SUNDRY NOTICES AND REPORTS ON WELLS
*Do not use this form for proposals to drill or to re-enter an
abandoned well. Use form 3160-3 (APD) for such proposals.*

- Cimarex has chosen to drill this well with Patriot Rig 4. As a result, aspects of our surface use plan have changed.

Surface Use Plan Revisions
Franklin 18 Federal Com No. 4
18-15S-31E

**EXHIBIT B
PECOS DISTRICT - RFO
CONDITIONS OF APPROVAL**

Exhibit D – Rig Layout
Franklin 18 Federal Com No. 4
Cimarex Energy Co. of Colorado
18-15S-31E
SHL 375 FSL & 375 FEL
BHL 375 FSL & 375 FWL
Chaves County, NM

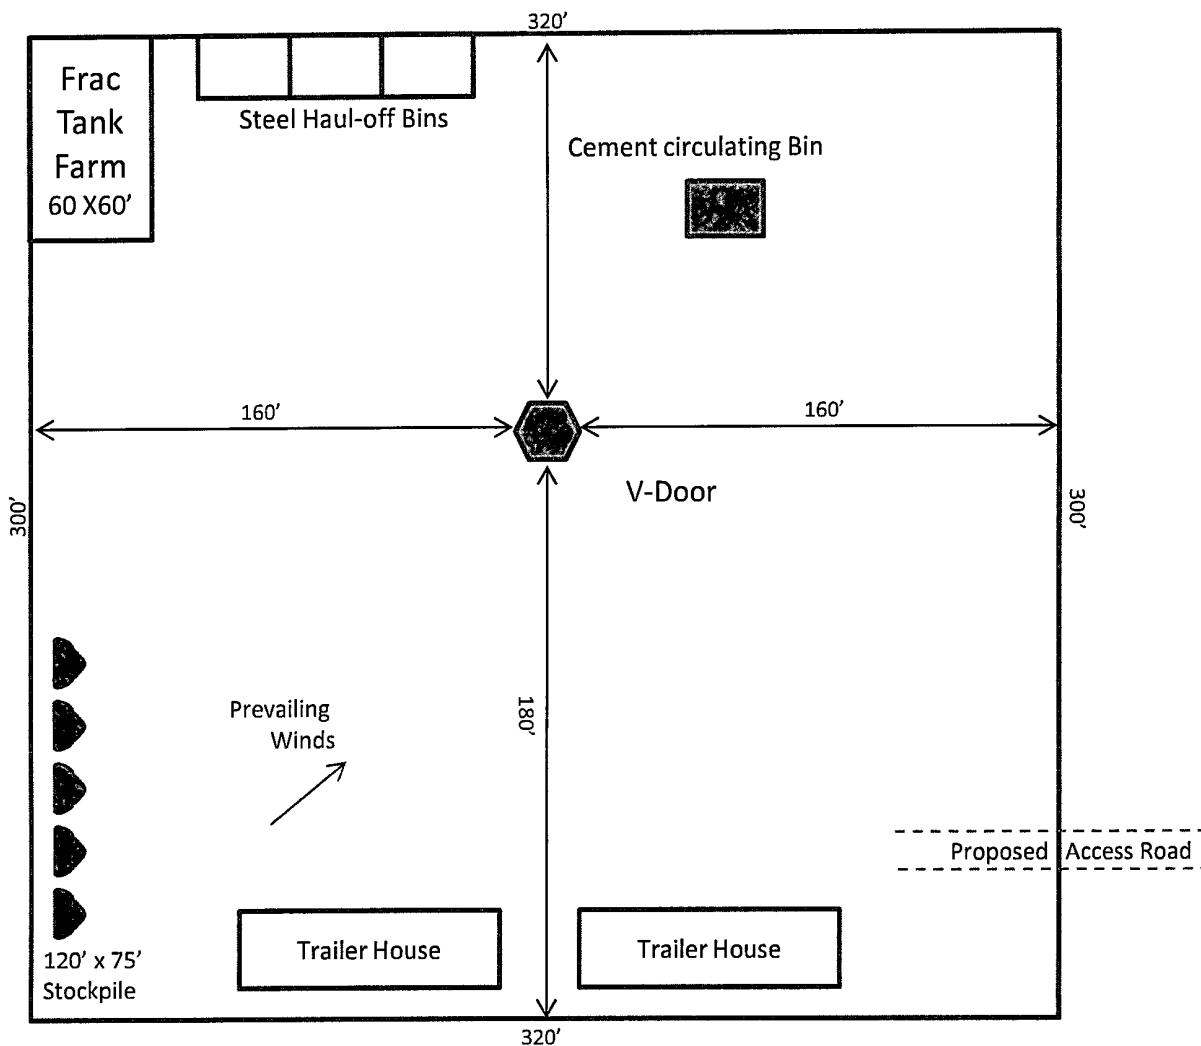
Attached are the relevant revised aspects of the Surface Use Plan as well as a revised Rig Plat.

- A. Exhibit "D" shows location and rig layout.
- B. Mud pits in the closed circulating system will be steel pits and the cuttings will be stored in steel containment pits.
- C. Cuttings will be stored in steel pits until they are hauled to a state-approved disposal facility.
- D. If the well is a producer, those areas of the location not essential to production facilities will be reclaimed and seeded per BLM requirements.
